802.3dj D1.0  
Comment Resolution - Electrical track  
Adee Ran, Cisco

- This slide package was assembled by the 802.3dj electrical editorial team to provide background and detailed resolutions to aid in comment resolution.
- Acknowledgement to Howard Heck, Adam Healey, Chris Diminico, Mike Dudek, Matt Brown, and Kent Lusted for reviewing and contributing to this work.
- Text in red indicates editors' explanation of the comments. Italics indicate an editor's observation which might be subjective.
- The responses to the comments may point to the slides for reference but the comment report is the official record.

Figure 176E-2—Components of a 200 Gb/s per lane AUI-C2M interface and insertion loss budget at 53.125 GHz

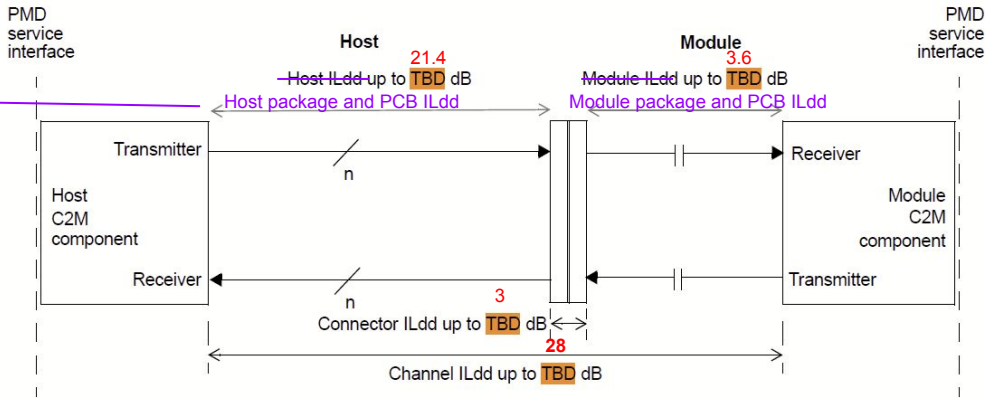
CI 176E SC 176E.2 P615 L23 # 129  
 Ghiasi, Ali Ghiasi Quantum/Marvell  
 Comment Type T Comment Status X  
 Figure depicts loss should be bump-bump  
 Suggested Remedy  
 ...application and the associated ILdd bump-bump budget at 53.125 GHz.  
 To make it more clear Host C2M Component should be changed to Host C2M Device and Module C2M Device

CI 176E SC 176E.2 P615 L33 # 130  
 Ghiasi, Ali Ghiasi Quantum/Marvell  
 Comment Type T Comment Status X  
 Loss budgets are TBD  
 Suggested Remedy  
 See Ghiasi C2M May-24 Contribution for background on the numbers  
 IIDD=28 dB  
 Connector with one via = 3 dB  
 Module lldd = 3.6 dB  
 Host lldd=21.4 dB

CI 176E SC 176E.4.1 P632 L6 # 73  
 Lusted, Kent Intel Corporation  
 Comment Type TR Comment Status X  
 The IL\_dd for AUI C2M channel is a TBD  
 Suggested Remedy  
 Set IL\_dd = 33 per [https://www.ieee802.org/3/dj/public/24\\_01/lusted\\_3dj\\_03\\_2401.pdf](https://www.ieee802.org/3/dj/public/24_01/lusted_3dj_03_2401.pdf)  
 Proposed Response Response Status O

The referenced presentation is [https://www.ieee802.org/3/dj/public/24\\_01/lusted\\_3dj\\_03\\_2401.pdf](https://www.ieee802.org/3/dj/public/24_01/lusted_3dj_03_2401.pdf). The comment is against 176E.4.1 (Recommended channel characteristics/Insertion loss), which has an equation for the ILdd limit. The suggested remedy does not address the equation. The proposed value for this TBD (Channel ILdd) is **33 dB**. Comment #134 suggests **28 dB** for the same TBD.
